PROJECT: Area 15

CITY OF LAS VEGAS		DATE:
INTER-OFFICE MEMORANDUM		March 8, 2018
TO: Land Development Services Department of Building & Safety		FROM: Albert Sung, P.E. Flood Control Project Engineer Department of Public Works
SUBJECT:	Drainage Study for: Area 15	
Cross Streets:	SWC of Rancho Drive & Sirius Avenue	
File Number:	F:\Depot\DSMemos\DS4921D.doc	
Parcel Number:	162-08-418-002	
Zoning Action:	SDR-70652	
FEMA Flood Zone	YES	NO X
Proposed Storm Drain	YES	NO X
COPIES TO:		Kimley Horn and Associates, Inc. Integral Partners Park Center Las Vegas, LLC Bart Anderson, P.E., DevCo CCRFCFCD NDOT

Technical Drainage Study Supplement 2 to Addendum 1

This report is intended to serve as Supplemental Information to Addendum #1 for the Area 15 Project. The comments in a letter from the Clark County Regional Flood Control District dated February 14, 2018 (included as **Attachment A**) and comment responses are included below. The responses are provided in italics.

**SIRIUS AVENUE
HEC-RAS EXHIBIT**

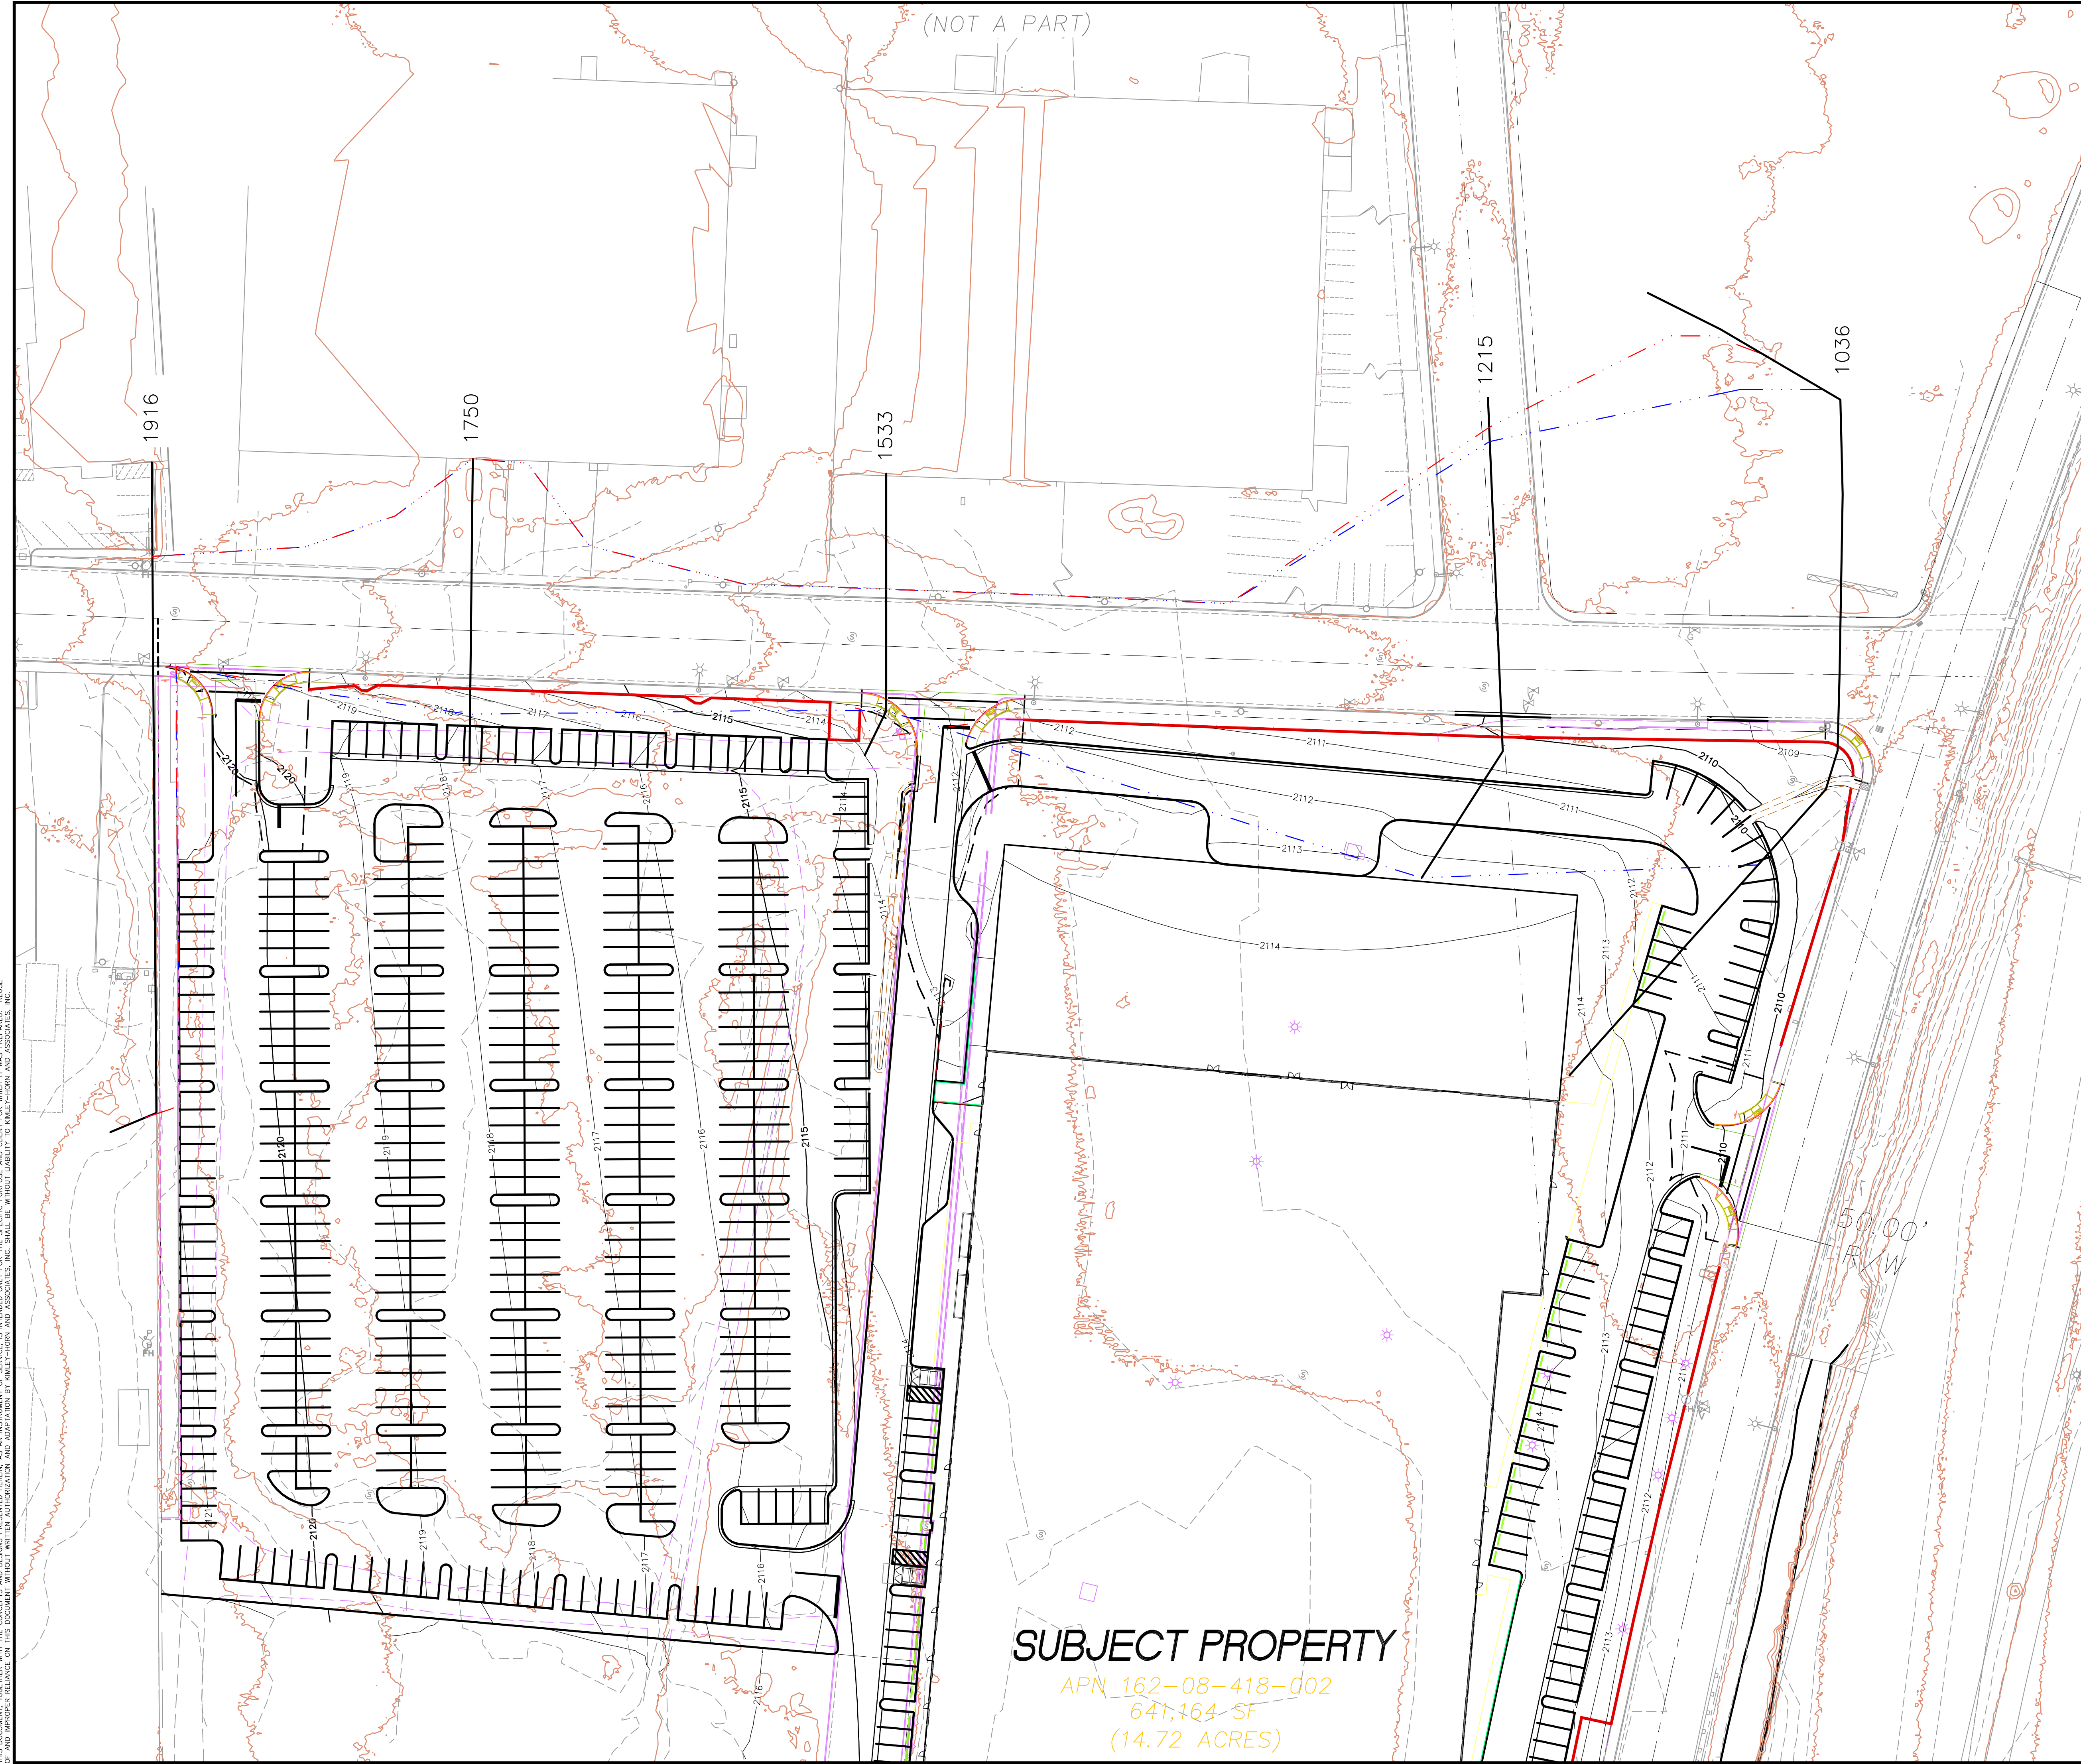
1. The project is proposing a 29" stem wall along Sirius Avenue that confines the flow to the right-of-way in order to protect the project site. However, this proposed improvement will potentially raise the water surface elevation on Sirius Avenue and may adversely impact the adjacent properties on the north side of the street and must be addressed. Per discussion with the City of Las Vegas, provide pre-development and post-project hydraulic analysis (HEC-RAS) for Sirius Avenue to ensure that the project does not impose a negative impact on adjacent properties.

*See **Attachment B** for the HEC-RAS analysis. The analysis shows little to no increase in most of the cross sections. The maximum increase, 0.39 ft occurs in the downstream-most cross section 1036. See **Attachment C** for an exhibit with the existing and proposed conditions flood inundation limits shown.*

OVERALL GRADING PLAN

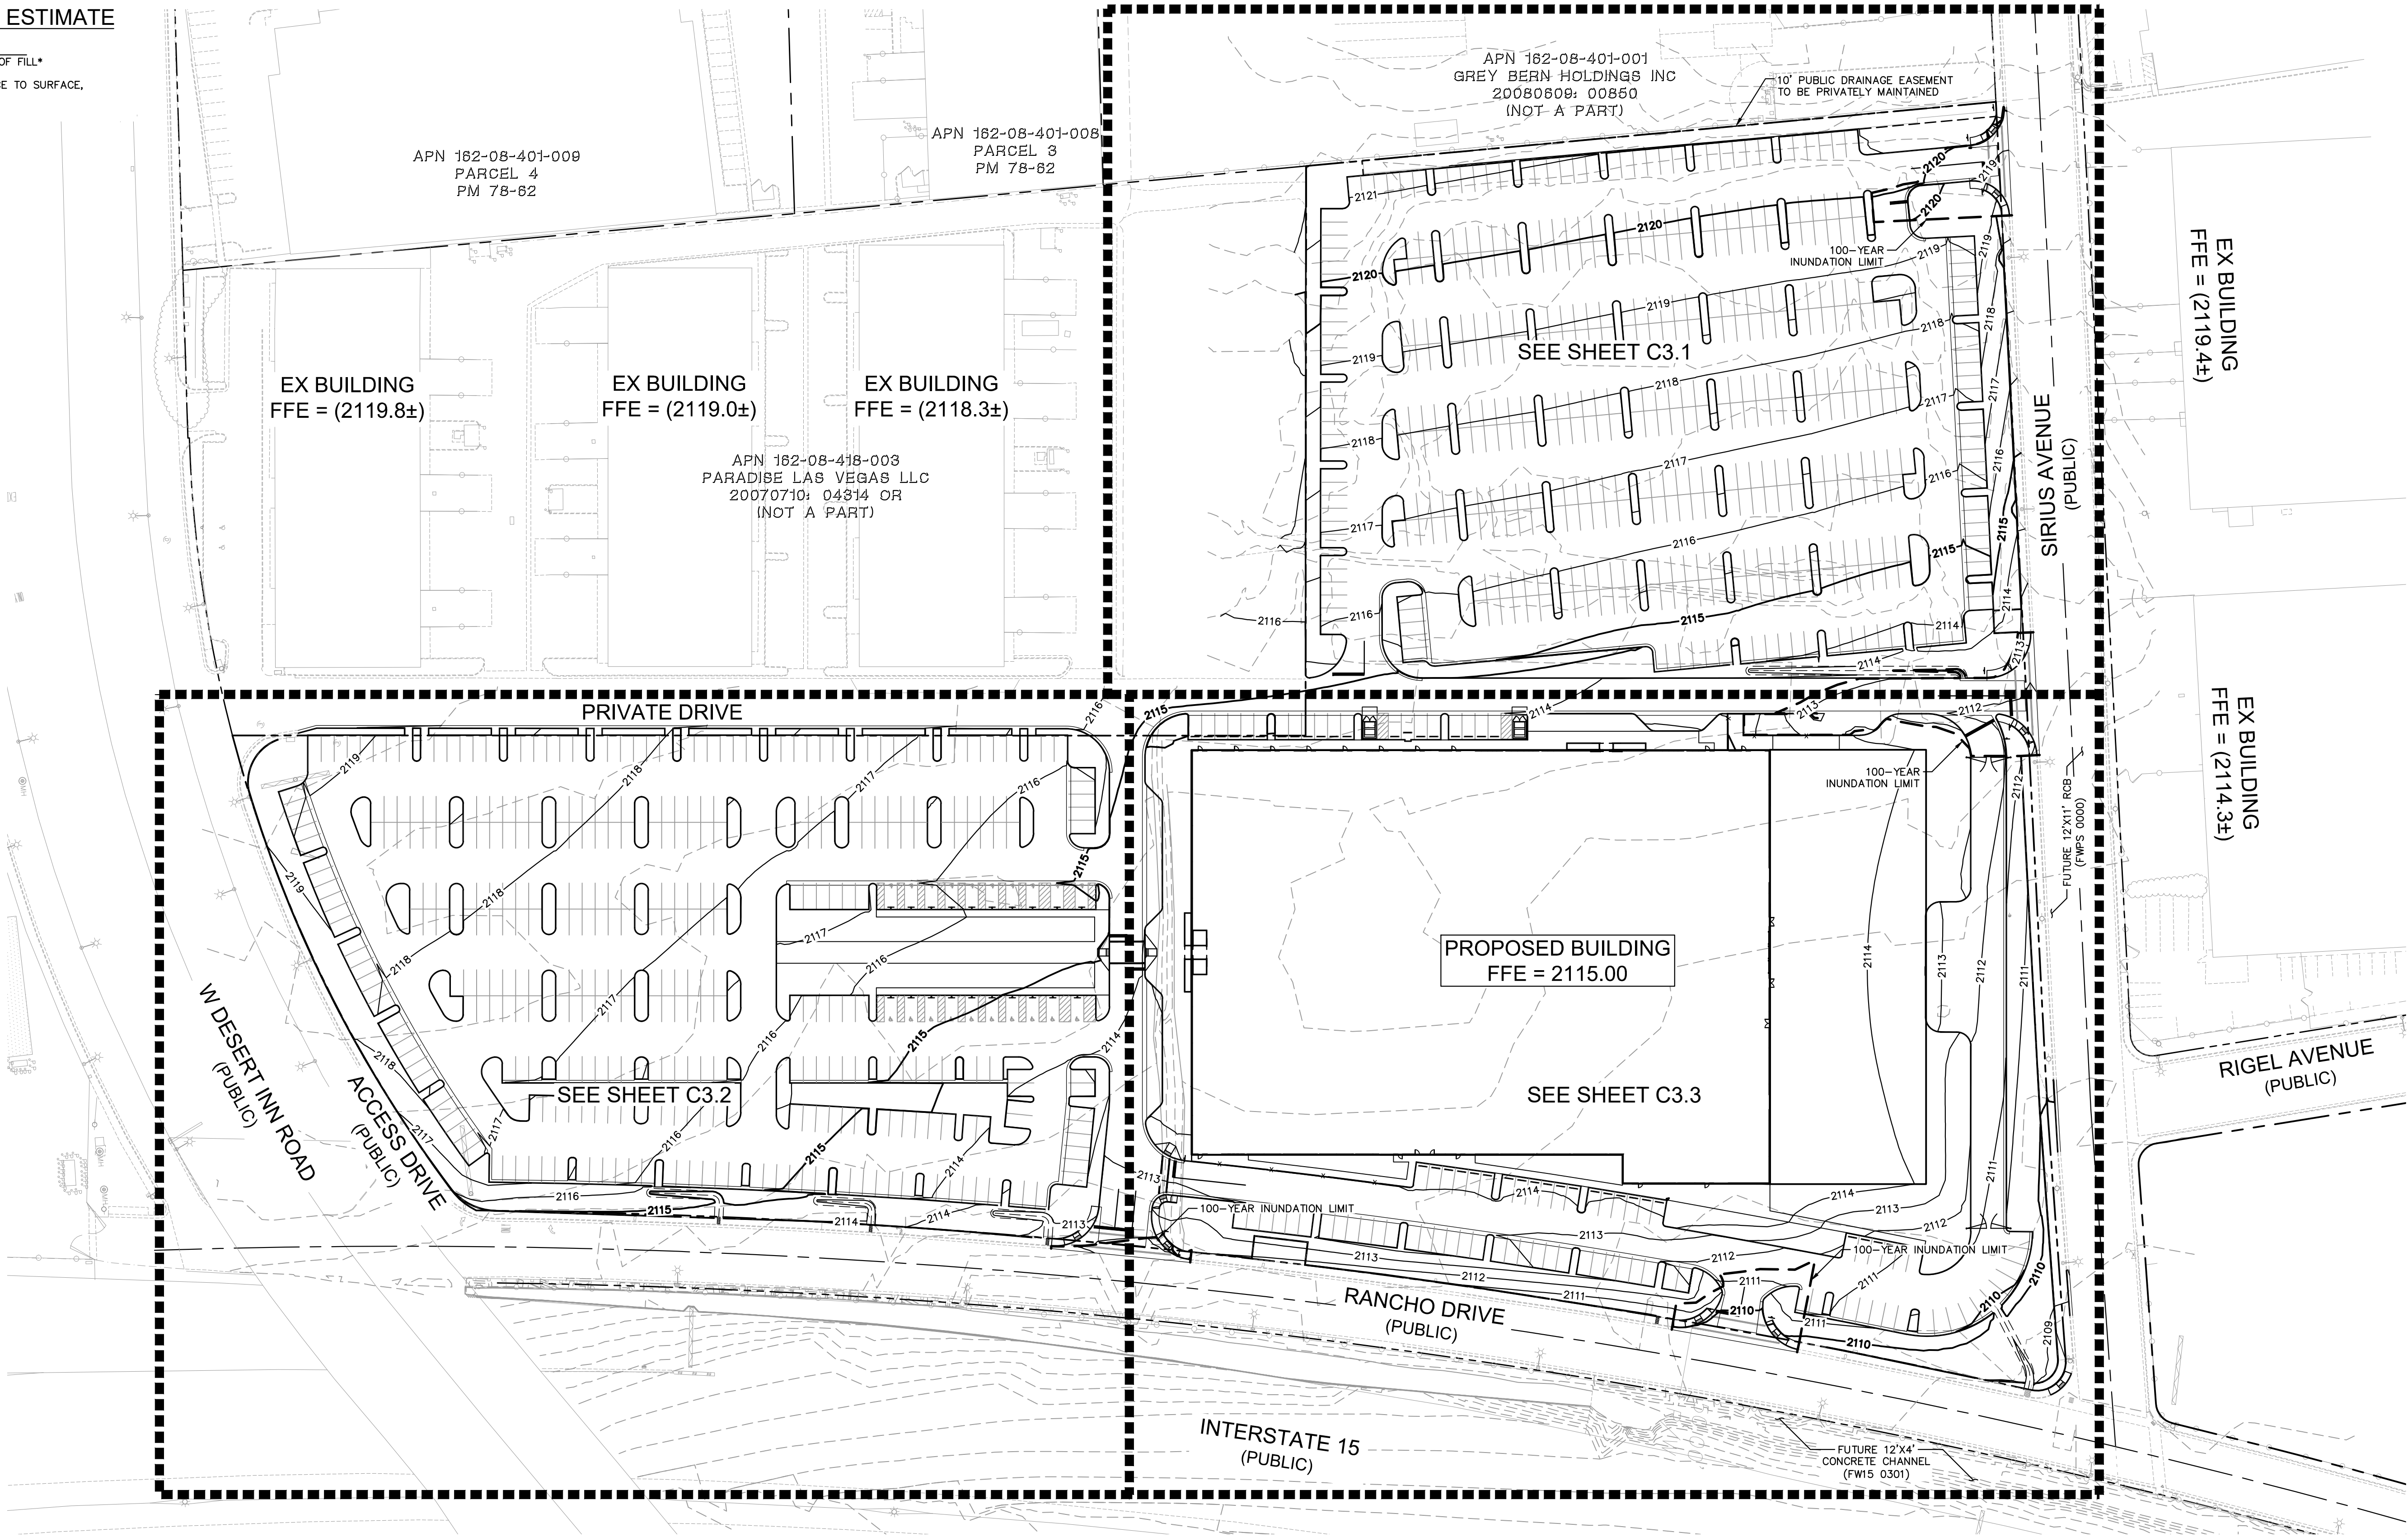
2. Label the existing Finished Floor elevations for the existing buildings on the north side of Sirius Avenue on Sheets C3.0, C3.1, and C3.3.

The plans have been revised per the comment.
